IAIN FROST SUBDIVISION, RESUBDIVISION OF LOTS 3 AND 4

Revised for the March 17, 2016 meeting:

DETAIL SITE PLAN

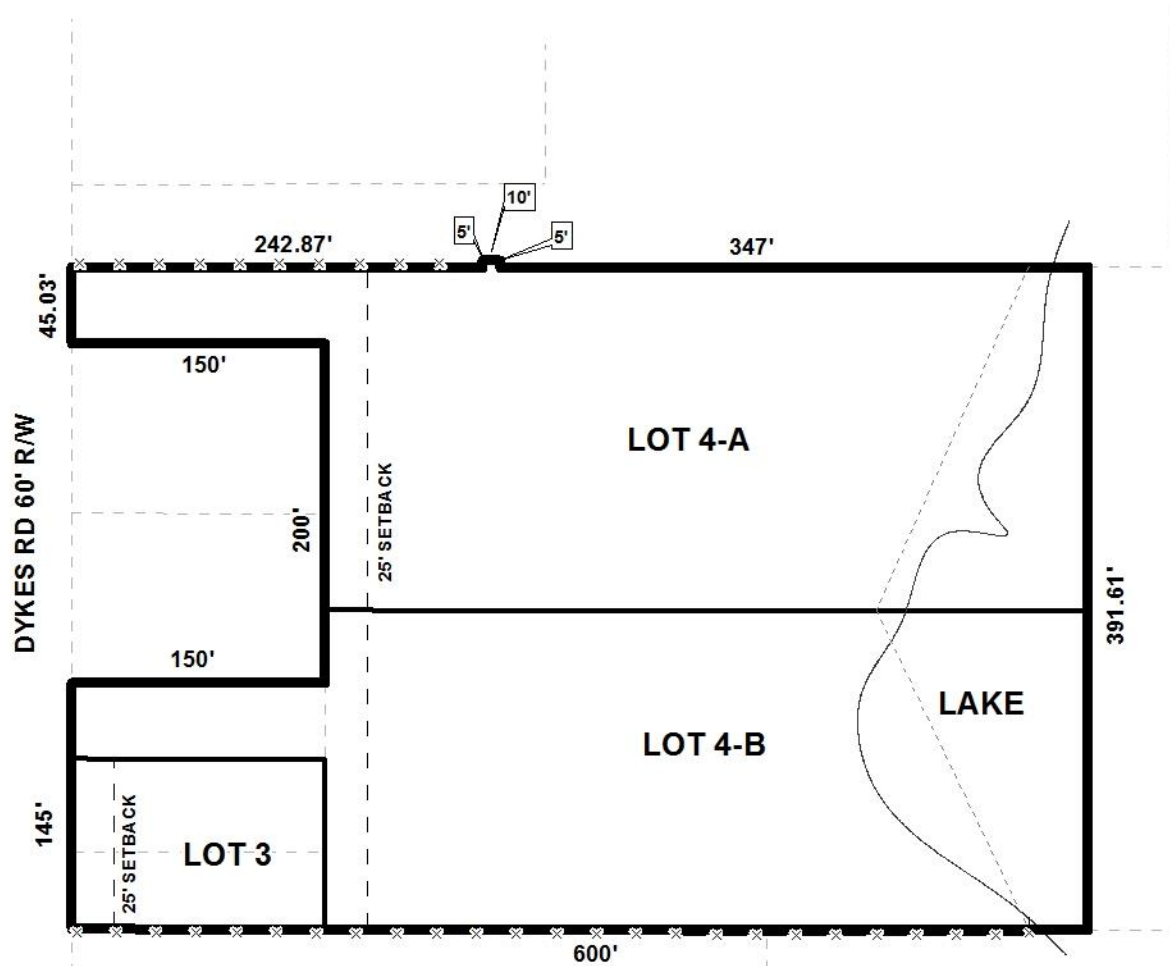
The preliminary plat illustrates the proposed 3-lot, 4.7 \pm acre subdivision which is located on the East side of Dykes Road South, 150' \pm South of Turmac Drive. The site is within the Planning Jurisdiction and the applicant states that the subdivision is served by public water and individual septic systems. The purpose of this application is to create 3 legal lots of record from 2 legal lots of record.

The applicant wishes to further subdivide two of the previous aforementioned lots (Lots 3 and 4) from two lots into three lots. Lots 1 and 2 are not included in this request.

As no justification was provided regarding the subdivision of Lot 4, and as no additional road frontage is being provided, staff cannot recommend approval of the request.

- 1) Previous Planning Commission approval included a condition of "no future subdivision of Lot 4";
- 2) No justification for the division was provided; and
- 3) No additional road frontage is proposed as part of the division.

To resubdivide the lot in this instance is not as simple as amending the note of the previously approved request to read as "No future subdivision of Lots 4-A and 4-B," as the Final plat and all required conditions have been recorded with Mobile County Probate Court. Furthermore, the site, as discussed in the aforementioned statement, does not present any physical constraints or issues that would call for further subdivision of Lot 4. Nor, is the resubdivision one that is of an innovative or unconventional design or a family division. Additionally, a revised preliminary plat was not received by staff indicating that additional road frontage will be provided as part of the resubdivision request.

The request to resubdivide Lot 4 appears to be based on a premise of "want" rather than on a premise of an unusual difficulty or innovative design, and is not part of a family subdivision.

- 1) Previous Planning Commission approval specifically included a condition of "No future subdivision of Lot 4;"*
- 2) The applicant's justification does not support a hardship based on the constraints of the site itself, an innovative design, or a family division of land, and is based purely on economics and the desire to do so; and*
- 3) No additional road frontage is proposed as part of the division.*
